Project
**Land at Tappers Farm
Oxford Road, Bodicote**

Drawing Title
**Elevations compared:
REM approved and
Tech design proposals**

Status
Planning
Drawn by
CAB
Checked by
-
Drawing No.
P/HT/200 / -
Revision

Technical
design stage
adjustment
Plt 45

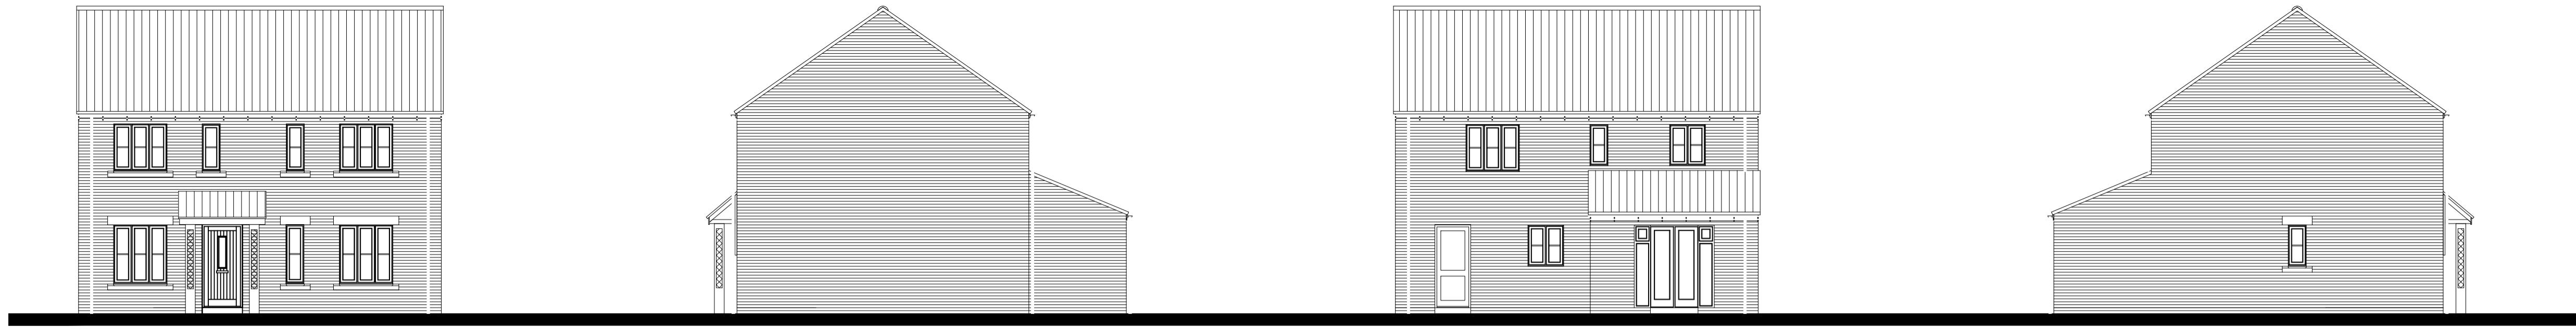
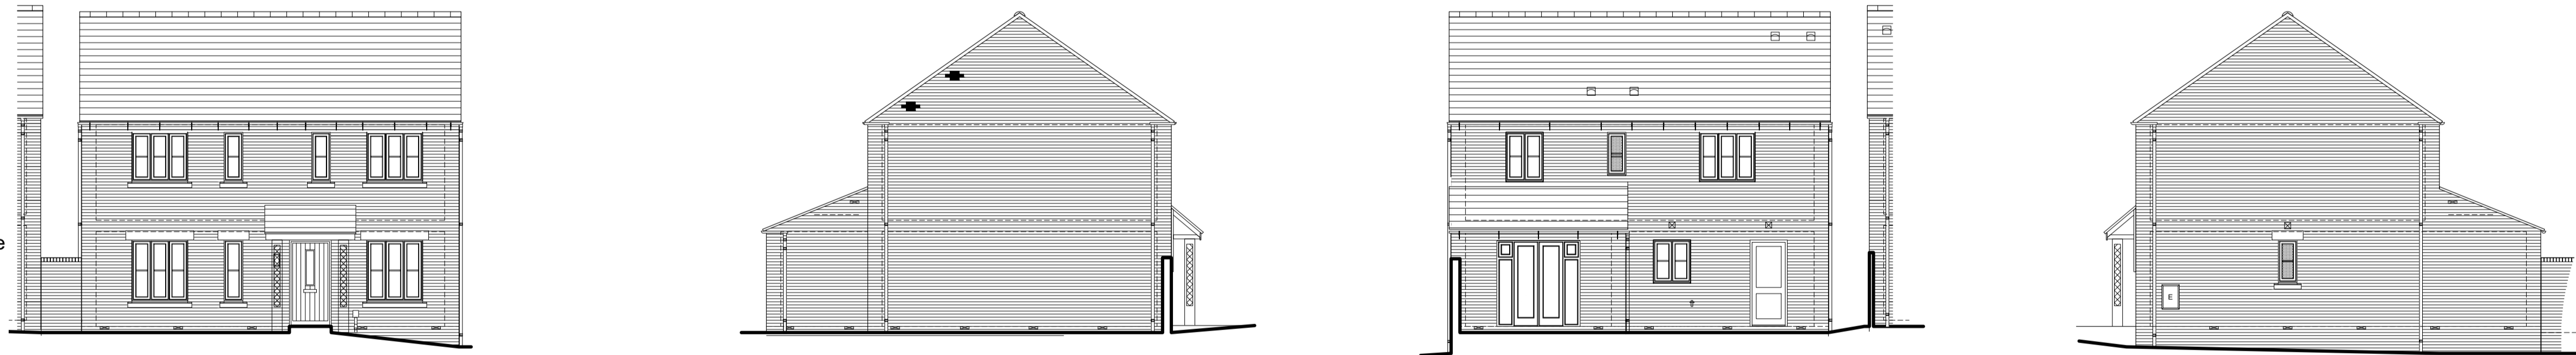
Notes:
- window 'A' omitted because it would face the adjoining neighbour's parking
- Utility window 'B' added for improved amenity and overlooking own parking
